**Committee of Experts on the Transport of Dangerous Goods
and on the Globally Harmonized System of Classification
and Labelling of Chemicals**

**Report of the Committee of Experts on the Transport of
Dangerous Goods and on the Globally Harmonized System of
Classification and Labelling of Chemicals on its eighth
session**

Addendum

**Amendments to the sixth revised edition of the Recommendations on
the Transport of Dangerous Goods, Manual of Tests and Criteria
(ST/SG/AC.10/11/Rev.6)**

Figure 39.1 (a)

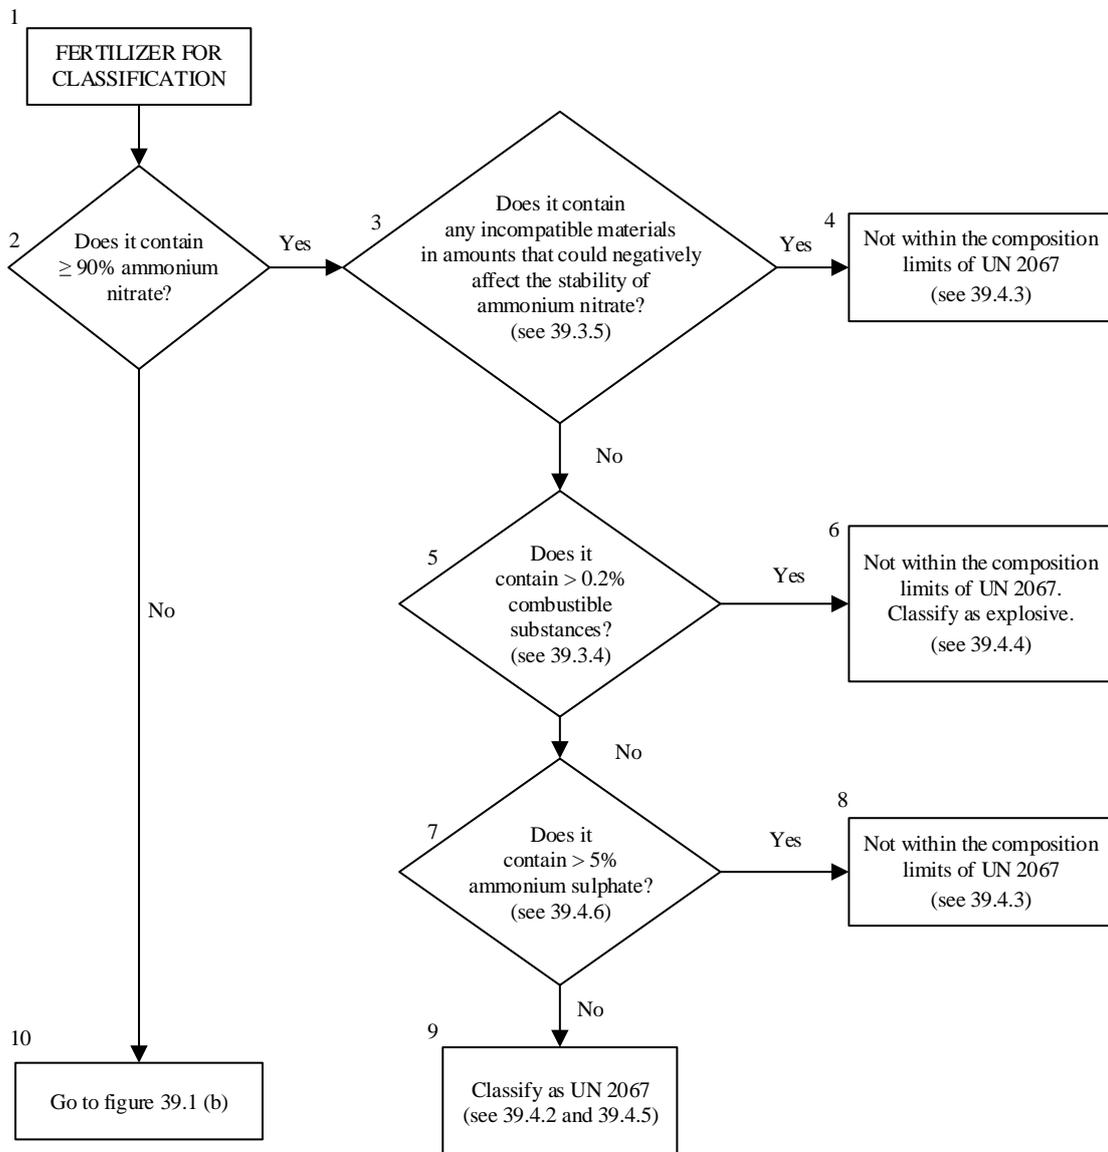
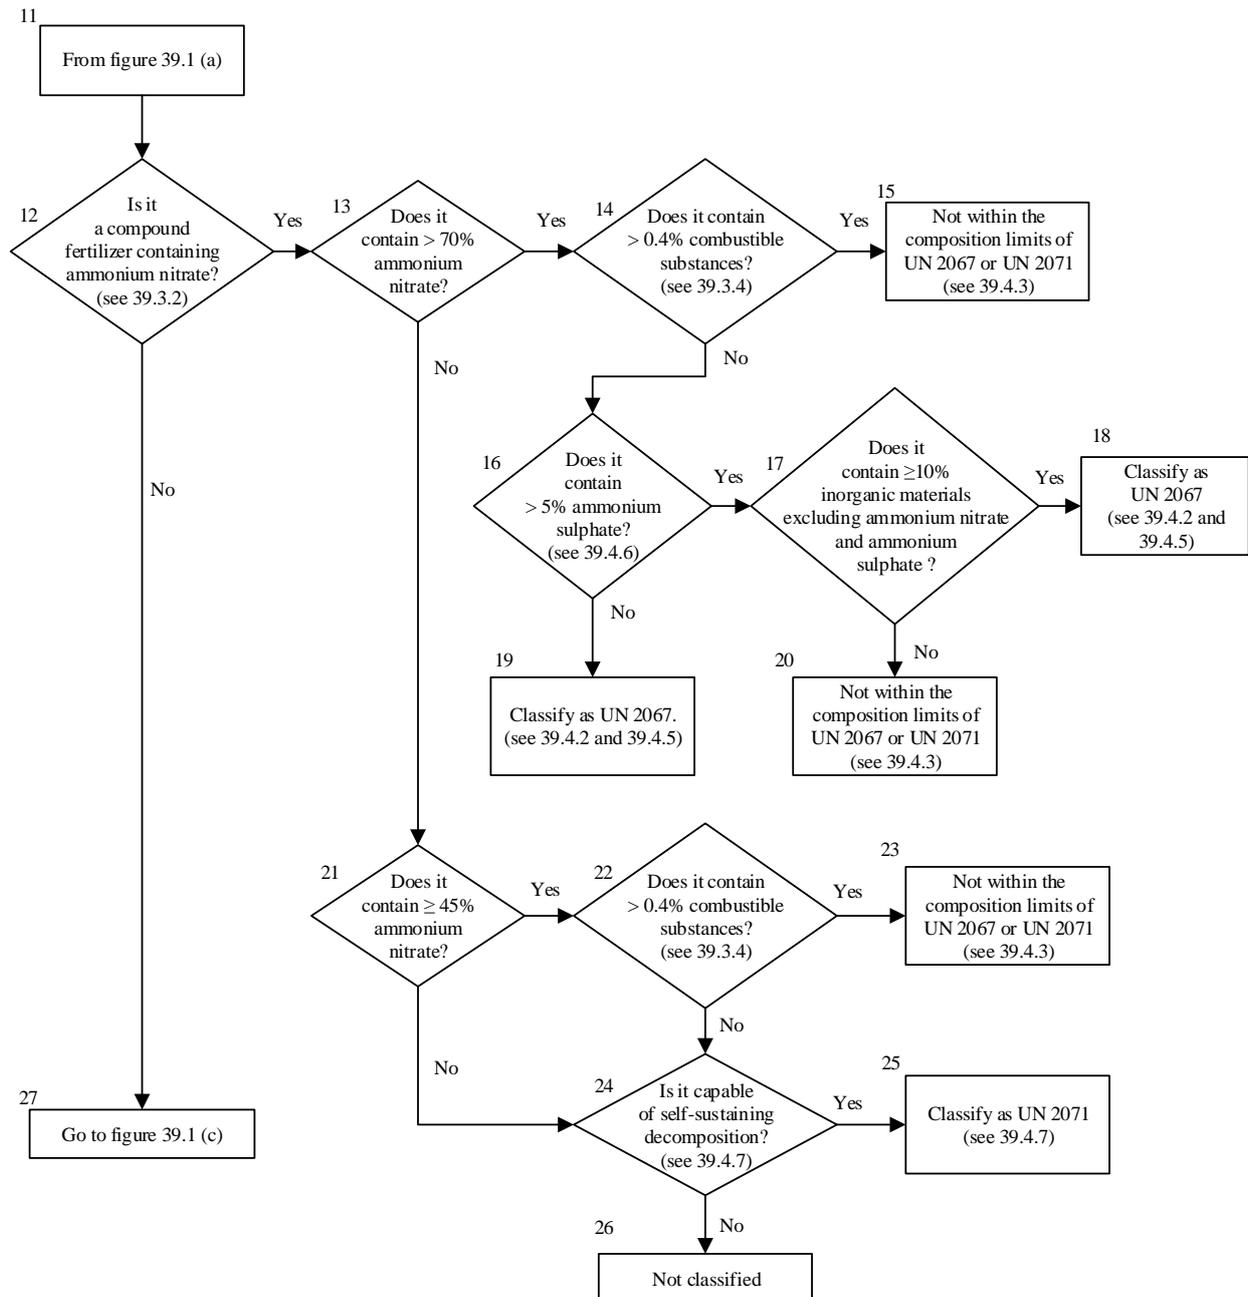
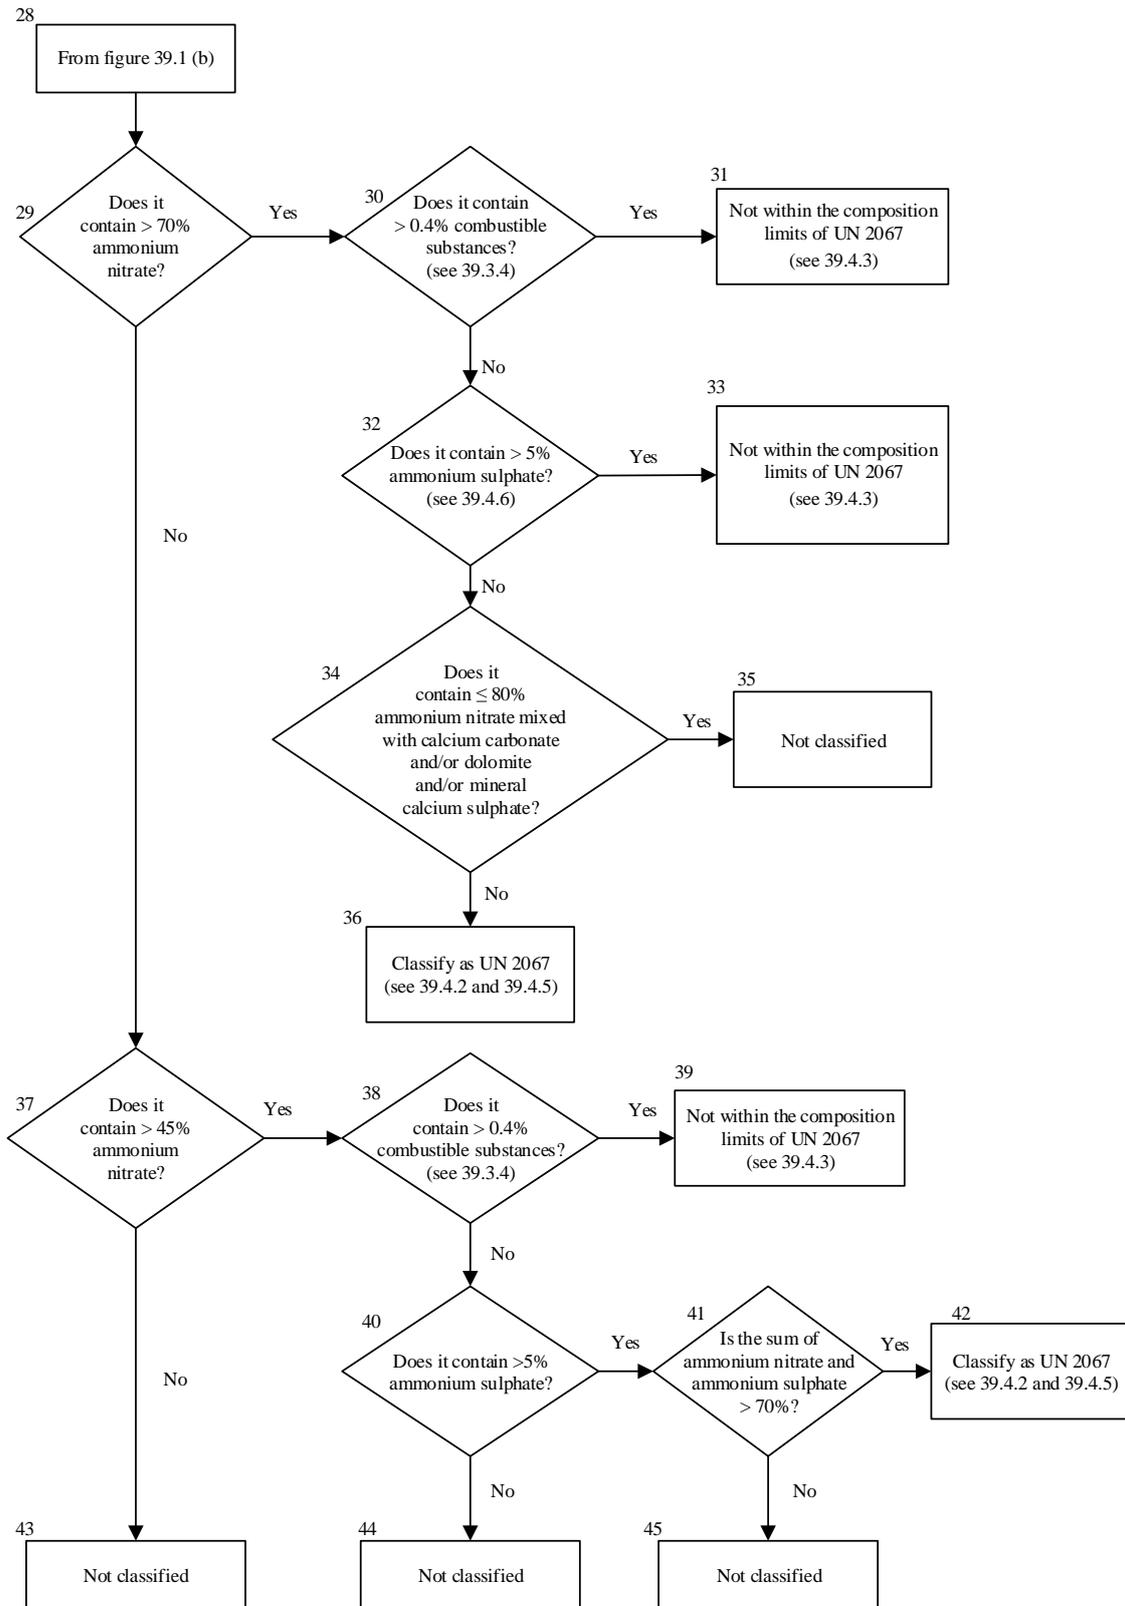
Add the following new section 39:

39.5.1 Ammonium nitrate based fertilizers shall be classified in accordance with the flowchart below.

Figure A7.10".

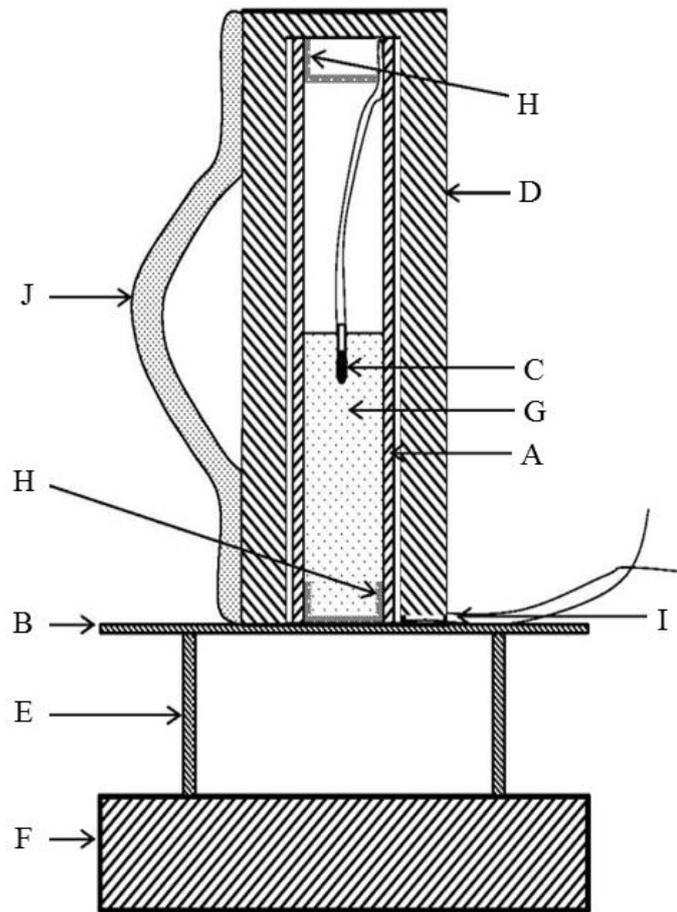
Insert a new section 2 to read as follows:

“2. US Flash Composition Test
